SERVICE TECHNICAL INFORMATION

ONE POINT REPAIR

REF. NO. : SI-95-055

MODEL : CA-DW700M / DW710M / NSX-E7M
SUBJECT : Measures to prevent locking of the CD mechanism
SYMPTOM : The mechanism becomes locked due to slippage of the 7-CD changer gear position. To prevent the mechanism from locking, perform the remedy described below.

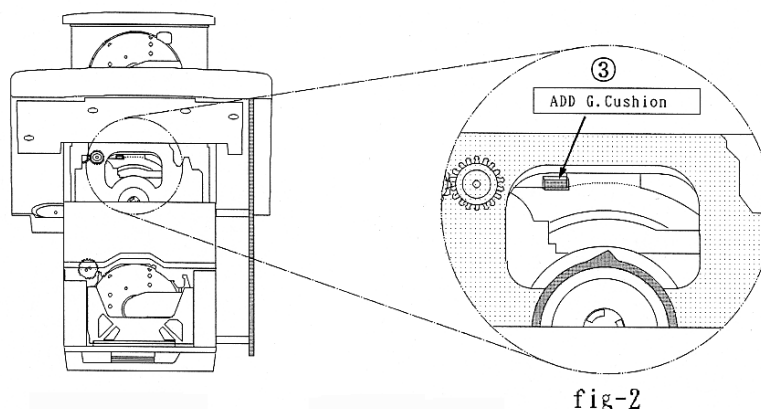
- ① Remove the rear cabinet.
- ② Check the position of GEAR, MECH A (chucking condition).
If there is slippage, adjust the position as shown below (fig-1).
- ③ Open TRAY L. Add a G • cushion to the position shown below (fig-2).
(with TRAY, DISC not in the chucking position)

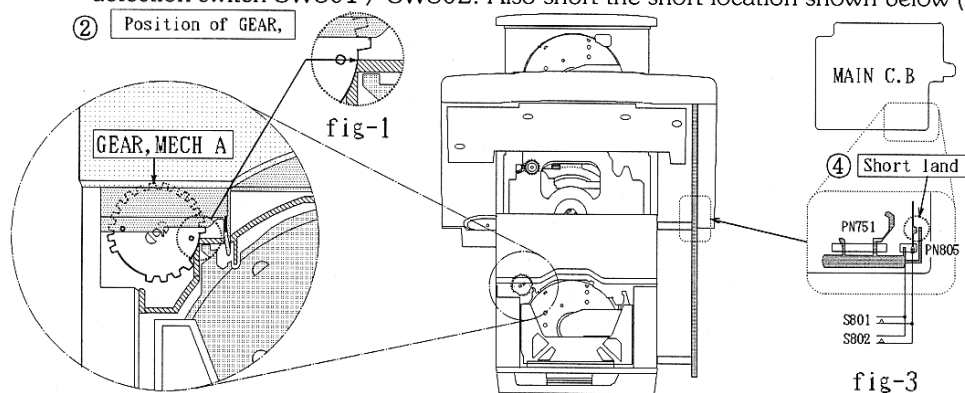
Note: When performing this remedy with the rear cabinet removed, short the inclination detection switch SW801 / SW802. Also short the short location shown below (fig-3).
